- 2A. Certified Survey Map to split the current lot located at 14** S. Six Points Crossing (Tax Key No. 454-0651-000) into two lots, submitted by Ian Martin, d/b/a Mandel Group, Inc.
- 2B. Site, Landscaping and Architectural Plans for The Market at Six Points Medical Office Building, a proposed medical office building and clinic, to be located at 6609 W. Greenfield Ave., submitted by Ian Martin, d/b/a Mandel Group, Inc. (Tax Key No. TBD via CSM)

Items 2A and 2B may be considered together.

Project: **AURORA HEALTH CARE - WEST ALLIS HEALTH CENTER**

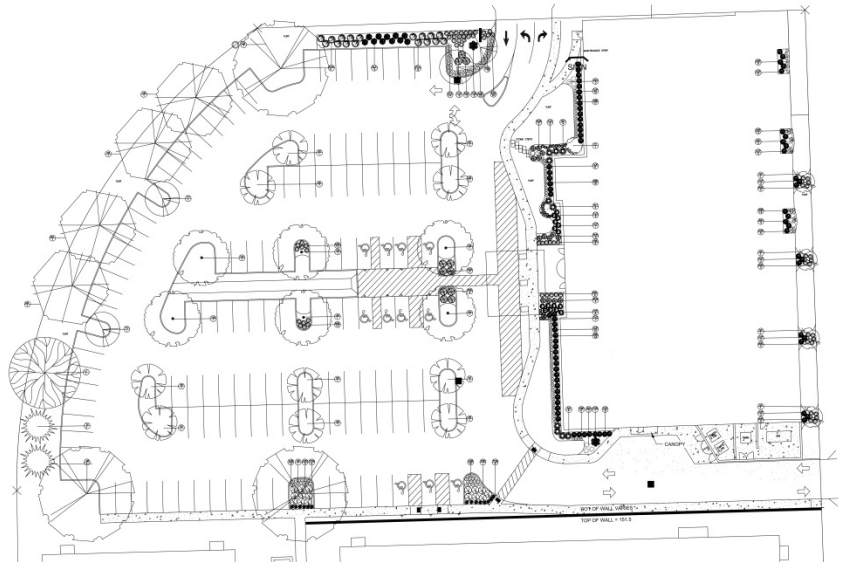
The site is generally laid out with the 30,000 sq. ft. building at the northeast corner, with the parking field located on the western half of the lot. A landscape buffer, which will double as snow storage, abuts the existing railroad spur. Two new driveways will be provided; one on W. Greenfield Ave. and the other just south of the building on S. Six Points Crossing. Pedestrian access is also provided at each of these driveways.

With the corner of the building sited to the edge of the property line, no room was left for landscaping to buffer or beautify the base of the building. Staff had initially recommended that the building be pushed back 3-5 ft. to allow for base landscaping, similar to the recent hotel redevelopment along W. Greenfield Ave., but was informed that there was no room on the site to accommodate that request. In exchange, the applicant offered to consider some sort of planter box along the step back of the building on W. Greenfield Ave. to help soften this edge. Details of that area are still outstanding and are being requested as a condition of approval.

As proposed, the driveway along W. Greenfield Ave. features a one lane entrance and a two lane exit. The entrance has been designed to encourage/require drivers to turn right into the parking lot and either park or circle to drop off patients at the doorway. Staff has worked with the applicants to make this directive clear, and believes that it can be adequately designed to do so. In relation to exit lanes, the City's Engineering Department has confirmed that one lane should be enough to handle the exiting capacity, and staff is recommending that the driveway be shrunk to do so, in an effort to keep pedestrian traffic safe along the corridor. Excess lanes/width at an uncontrolled intersection/driveway encourages faster driving behavior and does not match the desired neighborhood scale or redevelopment sought within the Six Points area.

Pedestrian access has been provided via sidewalks to the main entrance at each of the new driveways. That pedestrian access is also carried along the southern edge of the property to connect with a sidewalk path through the proposed apartment redevelopment. To most effectively define pedestrian cross access, staff has recommended that this connection be somehow carried up to W. Greenfield Ave. (as initially conceptualized) either through the parking lot via a dedicated path or within the landscaping along the western edge of the property.

Refuse and utilities (a generator and transformer) are contained within an integral masonry enclosure on the building's south elevation. Three sets of service doors are included, to provide internal access. Walls to the enclosure are nine feet in height. Due to the proximity of residential units overlooking this area, staff has recommended pergola or screen feature of some sort over the top of this area, and is recommending details as a condition of approval.

1. A revised Site, Landscaping and Architectural Plan being submitted to the Department of Development to show the following: (a) base landscaping along the north elevation of the building; (b) landscaping infill within all parking lot island/peninsulas; (c) the addition of "roof-like" screening atop the refuse area; (d) reduction of the exit along W. Greenfield Ave. to feature one exit lane; (e) details of pedestrian cross access from the south of the development to W. Greenfield Ave.; (f) stone veneer, or similar material/coloring applied to the base of the façade to help offset/accentuate the corner; (g) greater architectural expression of the northeast corner; (h) stone veneer to be carried to the base on proposed building insets; (i) greater material articulation along the south portion of the east façade; (j) greater material variation along the south elevation; (k) consideration of window headers or sun-screens, as architecturally compatible; (l) any other landscaping species/quantities recommendations as provided by the City Forester; and (m) bike parking facilities. Contact Bart Griepentrog, Senior Planner, at (414) 302-8469 with any questions.

Sheet: **EXTERIOR ELEVATIONS**

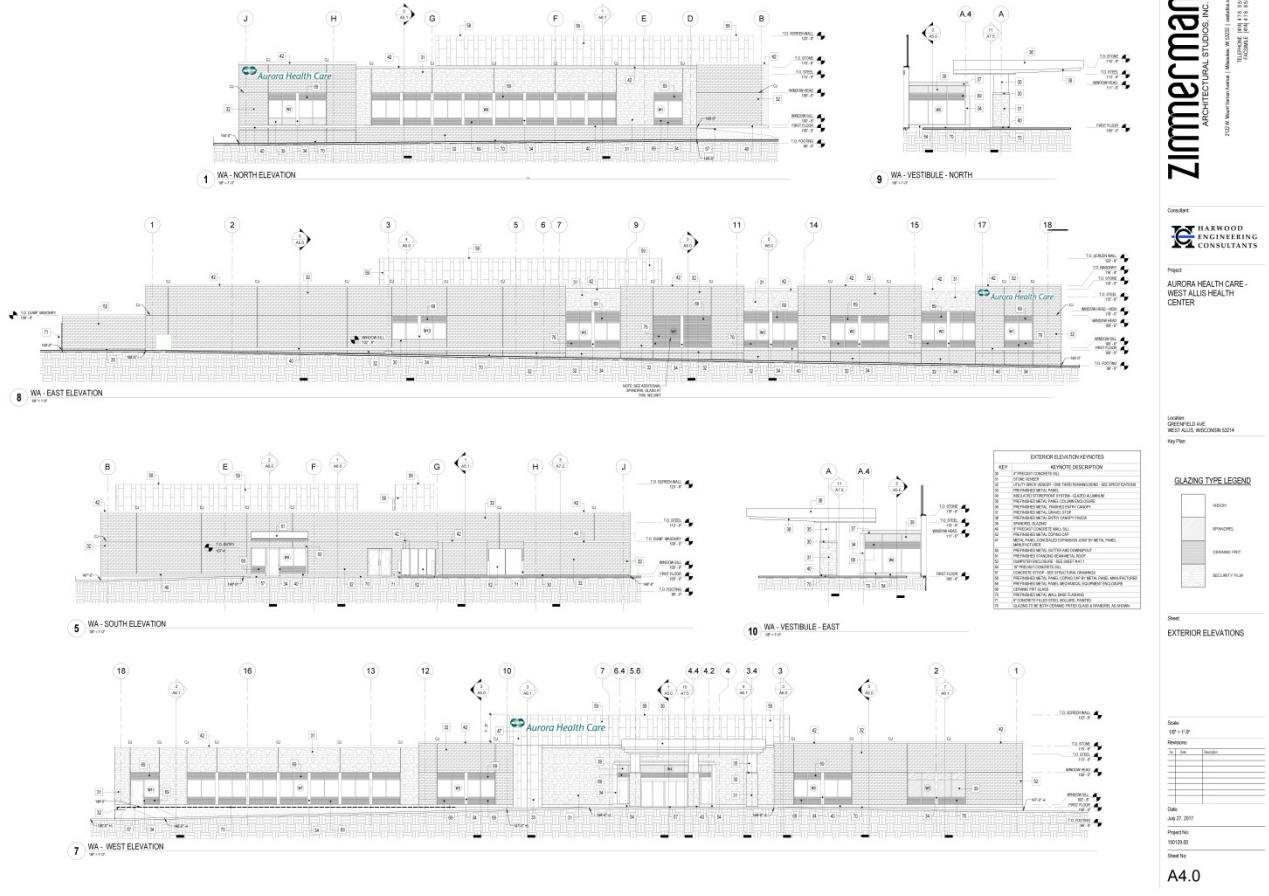
The exterior of the building will generally be clad in three primary materials, and two types of fenestration. Utility brick, stone veneer and greenish-gray metal panels will be used in various locations to help accentuate the contemporary design of the building. Transparent vision glass and "ceramic frit" glazing will also be featured throughout the design.

The western façade of the building fronts the parking lot and features the primary entrance. A drive-thru portico will allow patients to be dropped-off and picked-up under a covered canopy element. The northern half of this façade will be clad in stone veneer, as will the area surrounding the main doors. Brick veneer will comprise the remaining portion of the building pertaining to the lobby and pharmacy, which is dimensionally offset from the clinic portion. And, a pre-finished metal panel equipment enclosure will add height and a pop of color to the central area of the building.

Along the W. Greenfield Ave. street frontage, the stone veneer will be carried around the corner above the horizontal band that acts as a base window sill. For consistency, staff has requested that this stone veneer visually clad the entire area, similar to the corresponding western façade. The applicant has indicated a willingness to work on the concept, possibly by incorporating a landscape box feature. Satisfactory details are being requested as a condition of approval.

The northeast corner of the building is a visually prominent feature of the design, and the applicant has acknowledged this by conceptually placing signage at this location. Staff has asked for greater architectural thought here, possibly through the inclusion of greater height, a roof element, increased materials or expanded windows. The applicant is currently working with their architect to provide an updated concept, which will hopefully be ready by the time of the Plan Commission meeting.

The eastern façade facing S. Six Points Crossing features alternating projections of brick and stone veneer along the front half of the building. Staff has once again recommended that the stone veneer be carried to the base of the building, to offer a more cohesive visual break in the façade. The rear portion of this façade, whose floor plan corresponds to trash, maintenance and mechanical areas, is currently proposed as a large expanse of brick. Staff has asked the applicant to work with their developer to provide greater interest or definition to the area, and has requested an update as a condition of approval.

Moving along to the rear, south side of the building, brick is wrapped around the corner and also featured along the integral refuse/utility enclosure. A set of service doors is located centrally on this façade, aside a more formal entrance to the clinic's pharmacy. This pharmacy door features an aluminum canopy to signify its public entrance. While appreciative of the material quality proposed in this area, staff has suggested that some additional material variation could be added, to help break up the expanse and provide visual interest to the adjacent residential tenants.

Windows throughout the building are a prominent component of the design. The central component of each window unit generally features vision glass, while the upper and lower portions contain a mixture of ceramic frit and limited spandrel glazing. The "ceramic frit" glazing features horizontal white banding to help provide privacy/screening into the building, and spandrel is utilized only in the sensitive areas.
